STATE OF IOWA

RE: Former Sunray DX Bulk Terminal, 15150 Partridge Ave., Mason City

A revised PVC Water Main Replacement Work Plan for the above-mentioned site was received by the Department on March 17, 2008. The plan was developed and submitted as an attempt to comply with Iowa Tier 1 Standard that sets the benzene concentration in groundwater that may be in contact with a plastic water line at 290 ug/L. The revised plan calls for the replacement of 120 feet of plastic water line with 120 feet of ductile iron but does not call for any further site assessment. The revised plan does provide for the installation of one additional down gradient well (MW-11/12R) in order to replace MW-11 and MW-12 which have been destroyed.

FIGURE 2b

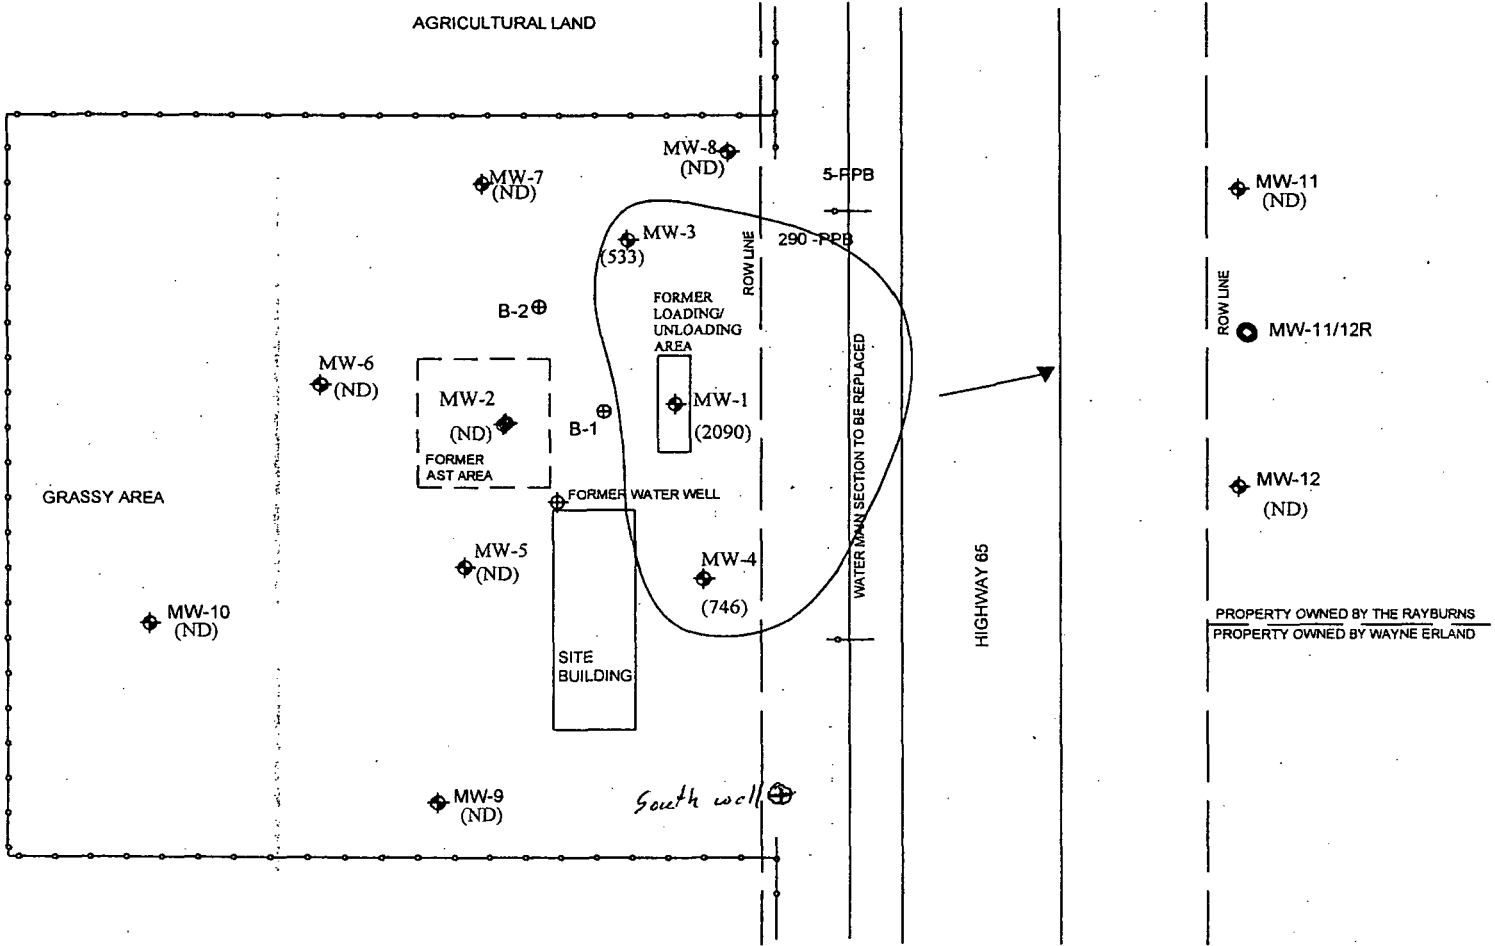
The plan does not provide any means to verify that the 120 foot long section will be sufficient to ensure compliance with the Tier 1 Standard. The Department will approve the revised PVC Water Main Replacement Work Plan with the following provisions. Adequate assessment must be performed to define the extent of detected groundwater contamination down to concentrations that comply with the appropriate Tier 1 Standard. This will require that more information be collected as to the northern and southern extent of the benzene plume. If MW-8 can be located and a groundwater sample collected, it may be used to define the northern extent assuming that the detected benzene concentration is either non-detect or comfortably below the Tier 1 Standard. No monitoring well is located near enough the water main to the south to determine the southern extent of the benzene plume. An additional well will need to be sited south of monitoring well MW-4 and east of monitoring well MW-9. (See attached). If the north monitoring well (MW-8) needs to be replaced, that replacement well, the new south monitoring well, and MW-11/12R will need to be monitored to demonstrate plume stability. Any new wells installed on-site should be finished as permanent wells to insure survivability. All wells currently on-site shall be maintained.
